HISTORIC AND DESIGN REVIEW COMMISSION

March 16, 2022

HDRC CASE NO: 2022-088
ADDRESS: 269 NORTH DR
LEGAL DESCRIPTION: NCB 6708 BLK 18 LOT 16- E 25 FEET OF 17
ZONING: R-6, H
CITY COUNCIL DIST.: 7
DISTRICT: Monticello Park Historic District
APPLICANT: Leonard C. McClure/MCCLURE LEONARD C
OWNER: Leonard C. McClure/MCCLURE LEONARD C
TYPE OF WORK: Modifications to rear accessory structure
APPLICATION RECEIVED: January 20, 2022
60-DAY REVIEW: Not applicable due to City Council Emergency Orders
CASE MANAGER: Katie Totman

REQUEST:

269 North Drive garage apt. North elevation
7.5" horizontal wood siding (not shown)

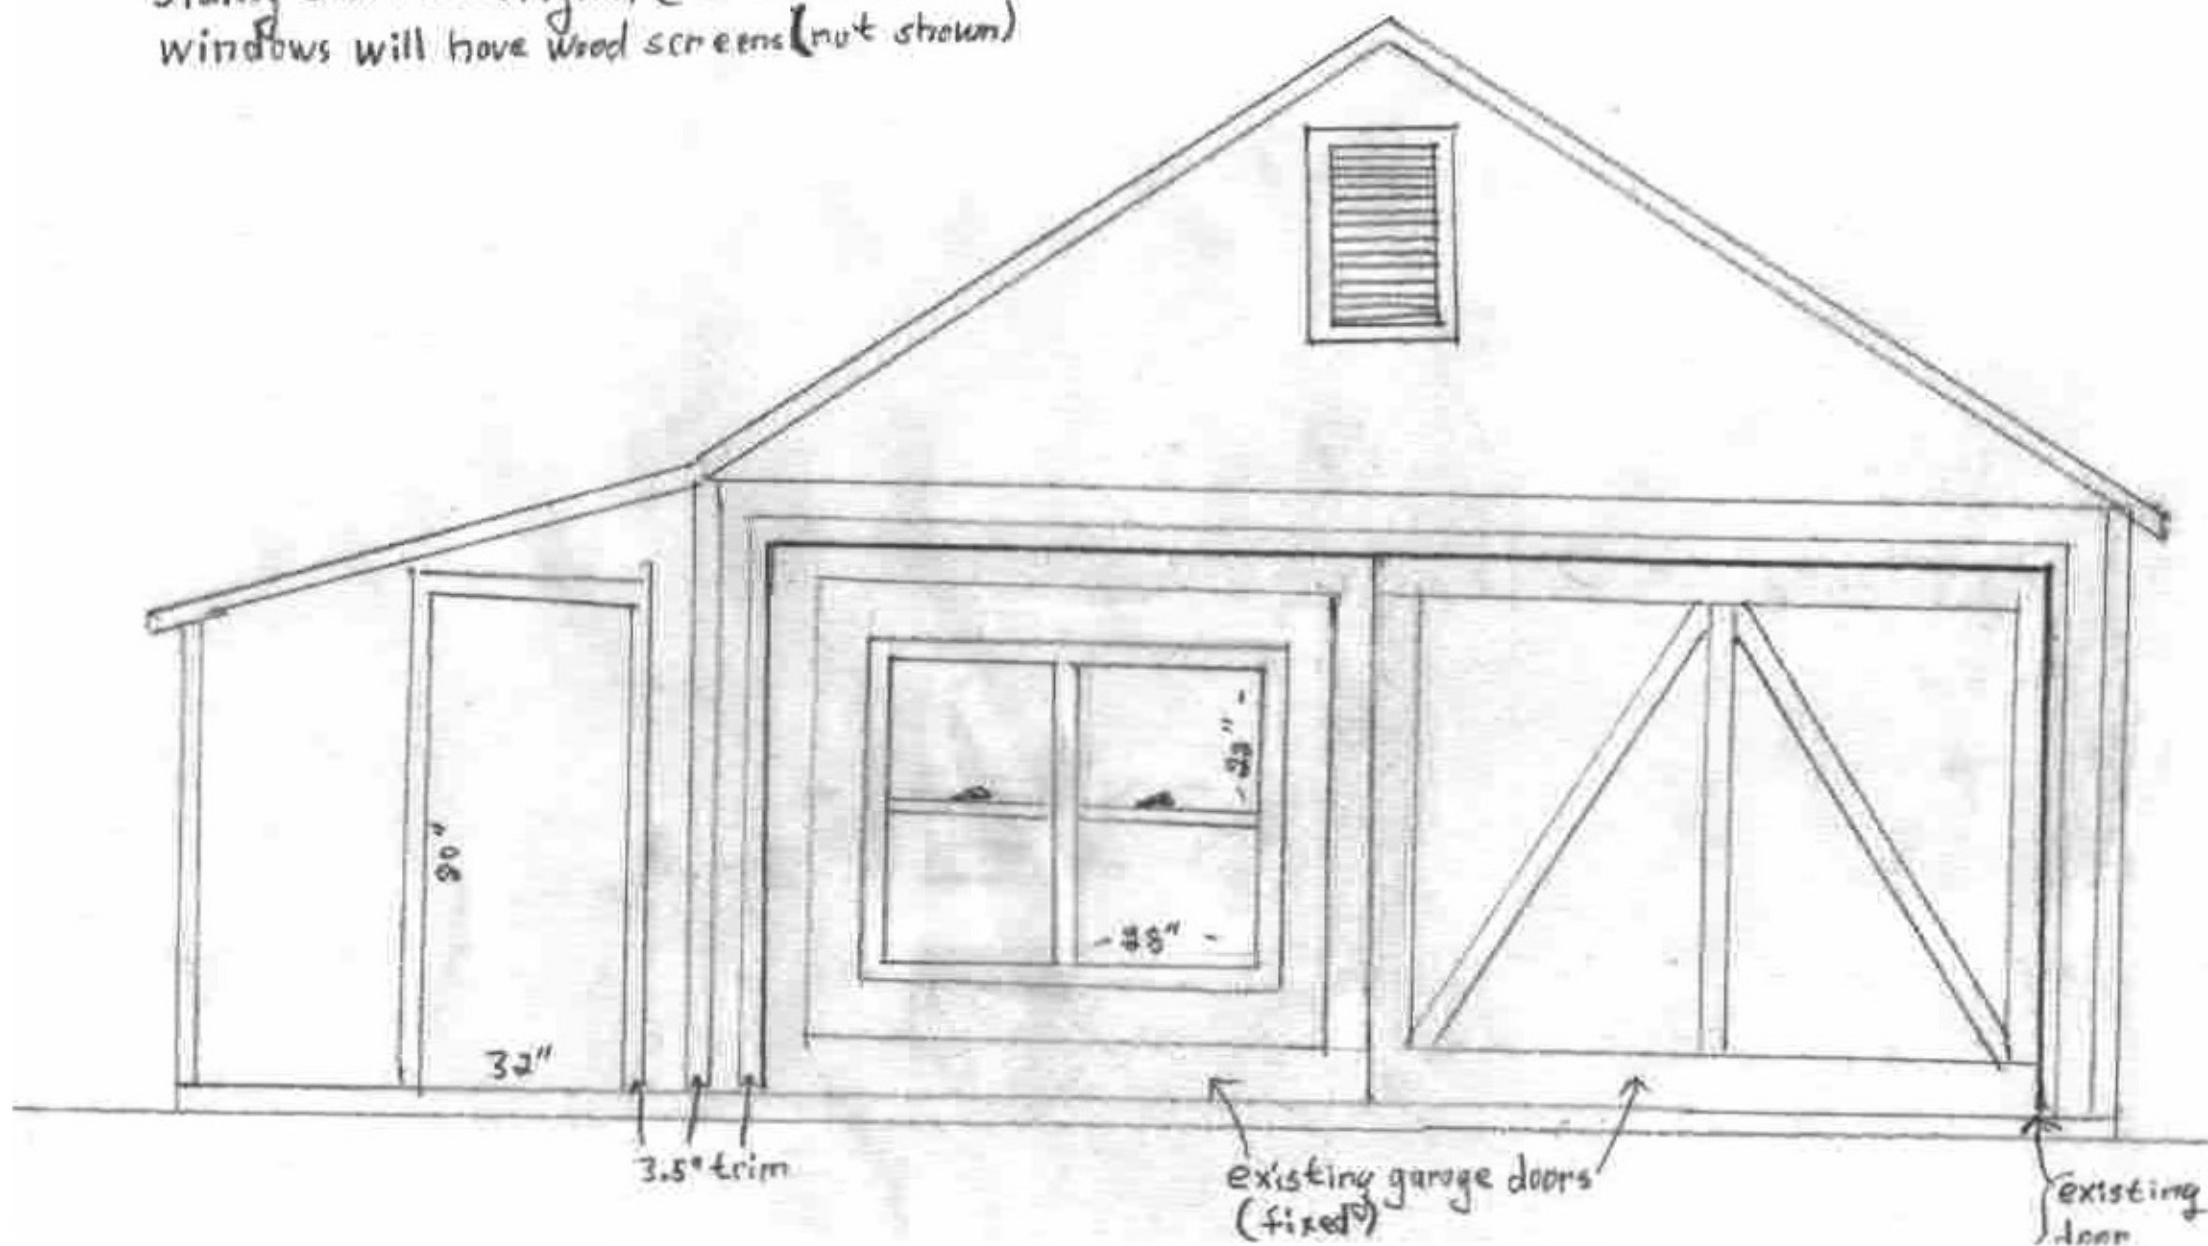
The only window in the existing structure is a small (24X36) double hung aluminum-frame window that faces the alley. In my original submission I left it out, but decided to keep it, along with its 3.5" exterior wood trim (see updated drawing of north elevation).

269 North Drive garage apt. West elevation

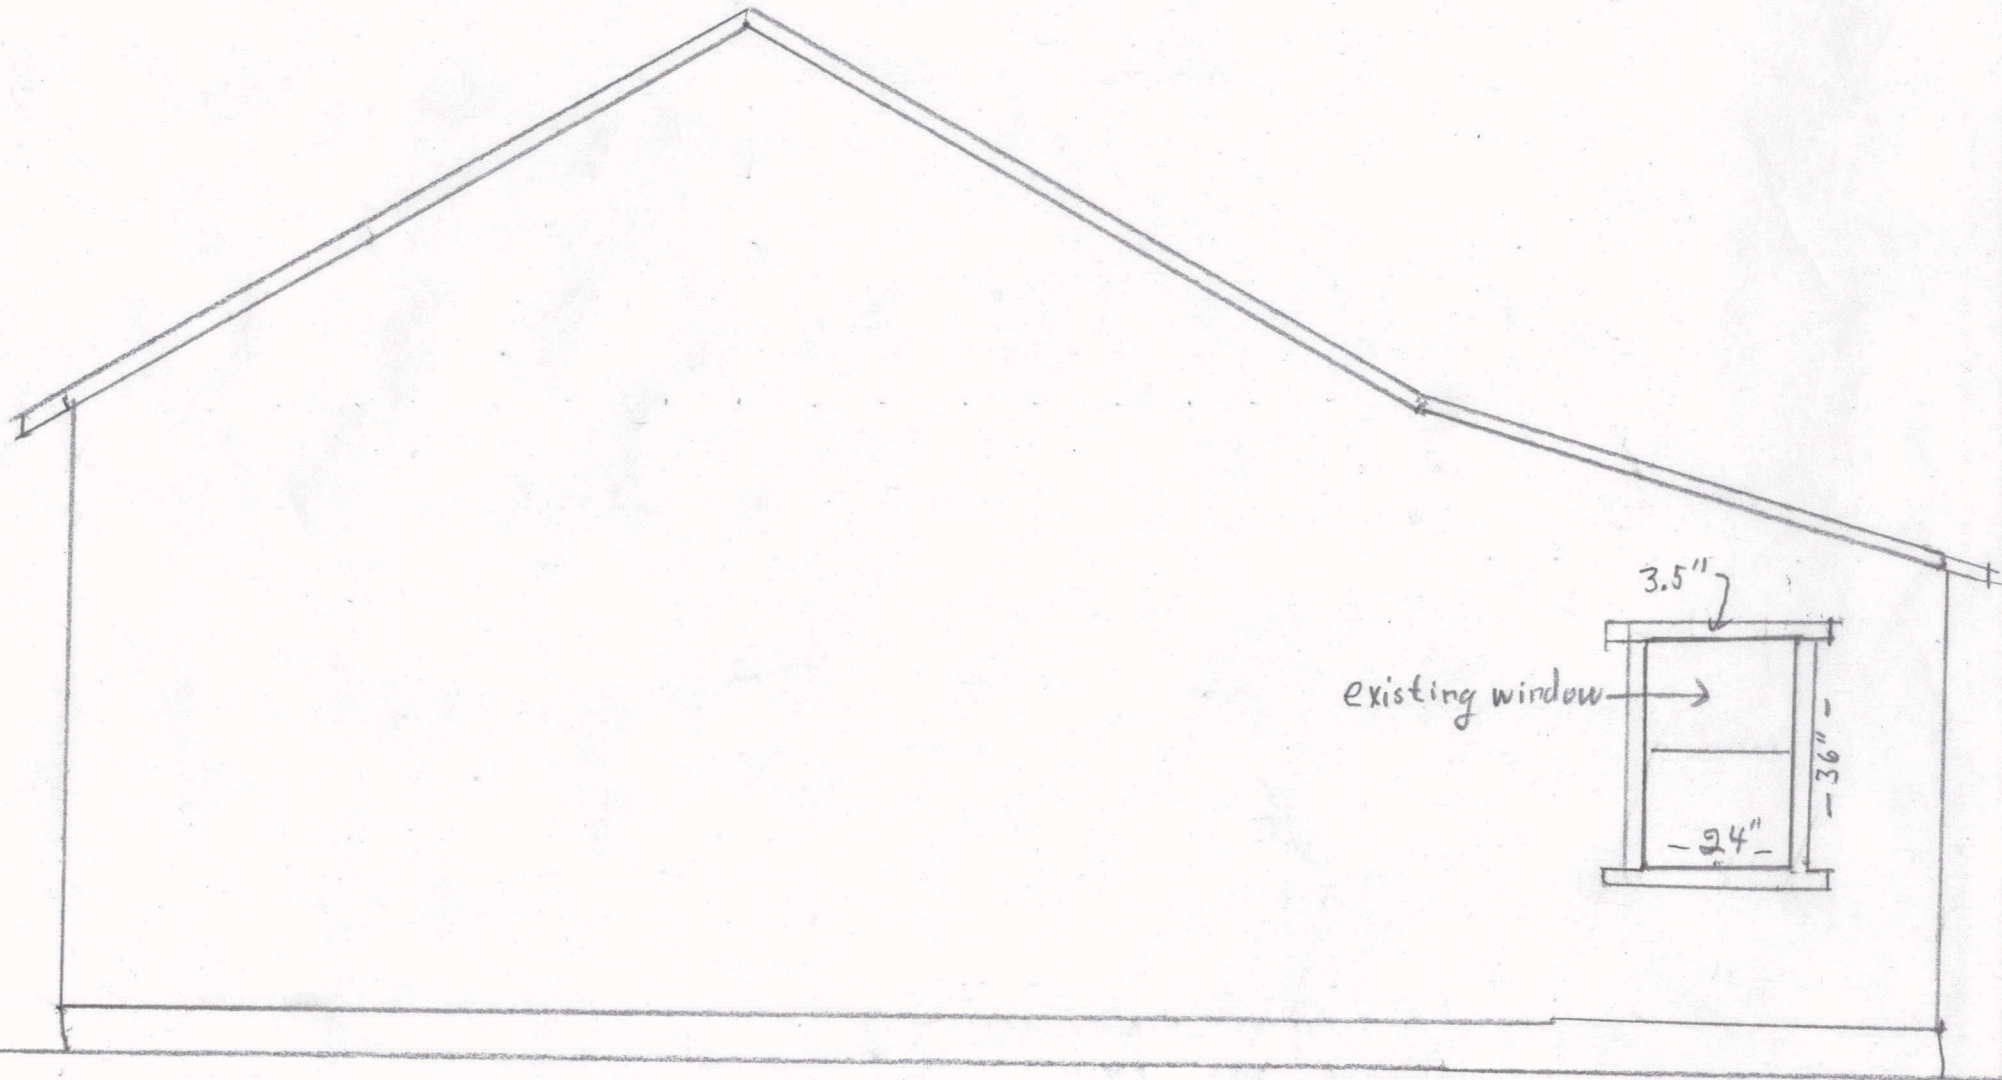
The set of windows on the west side, although not visible from the street, will be the same as the ones facing the street.

369 North Drive garage apt. East elevation

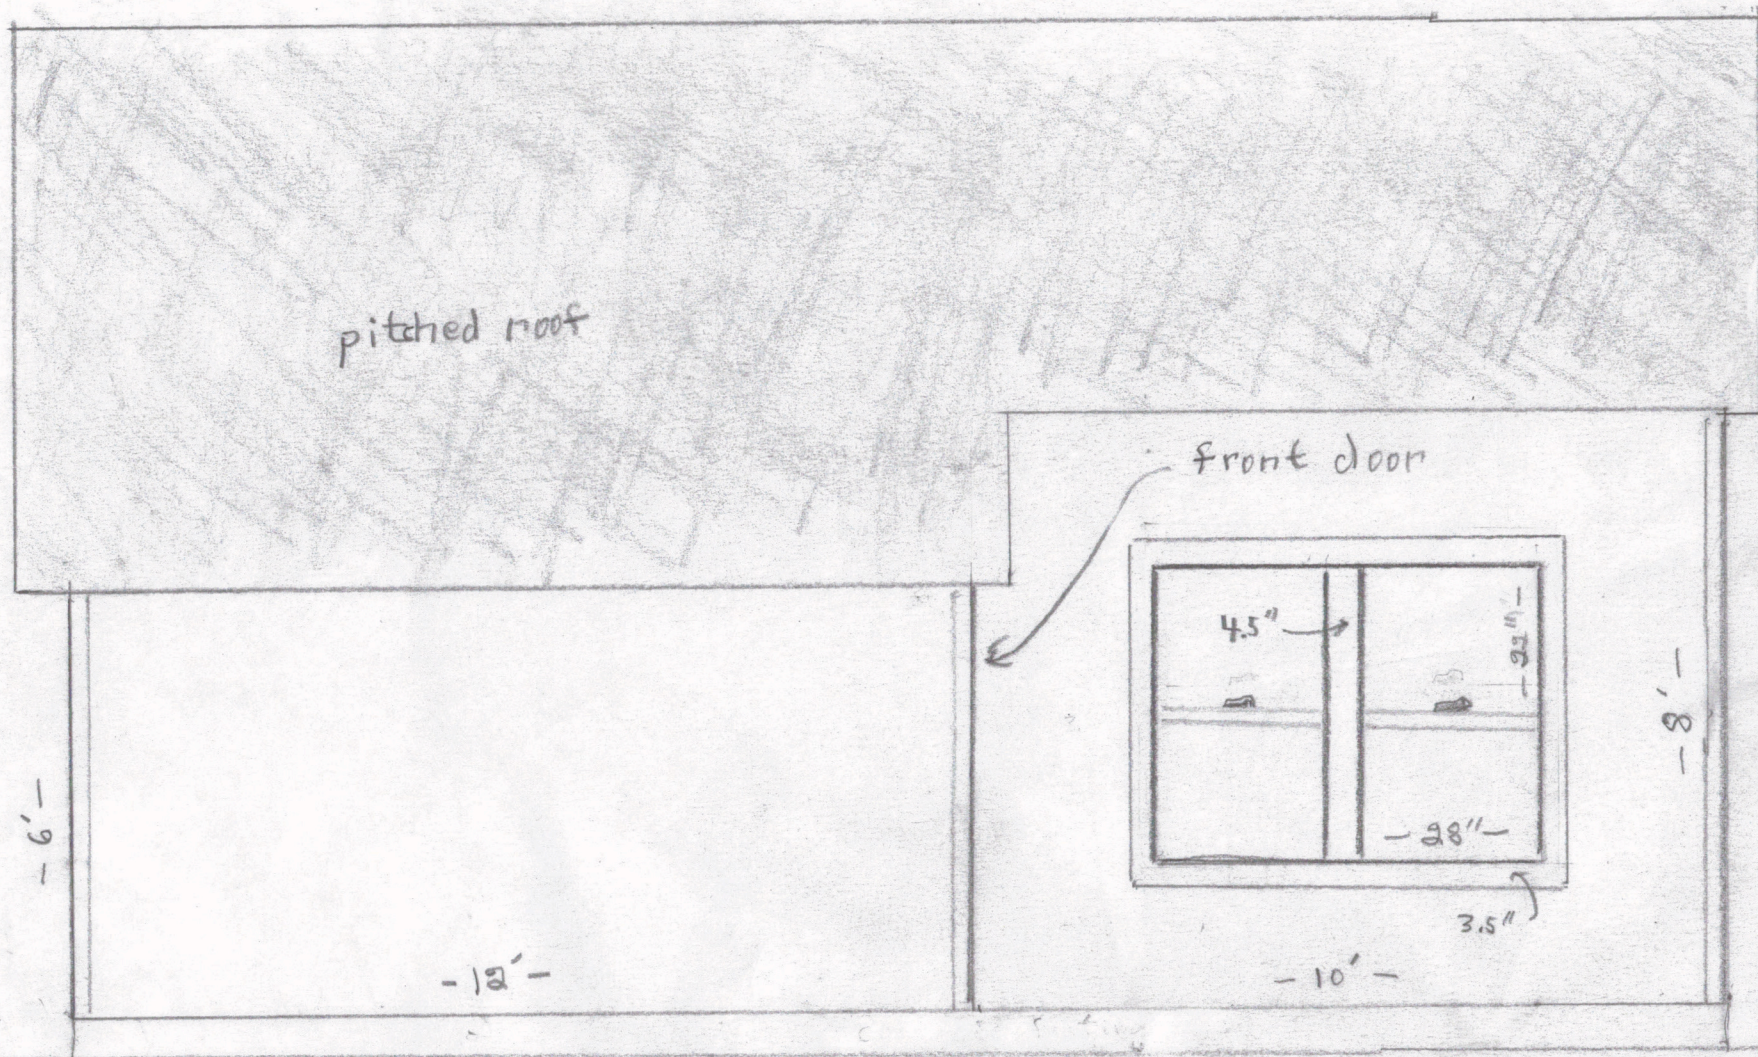
The two high windows on the east side are meant only for ventilation, and to let in some light in an otherwise dark interior. They are set high for security, as this is a hidden space near the alley, facing the neighbor's high wooden fence. They will be aluminum horizontal sliders with built-in screens. They are not visible from the street.
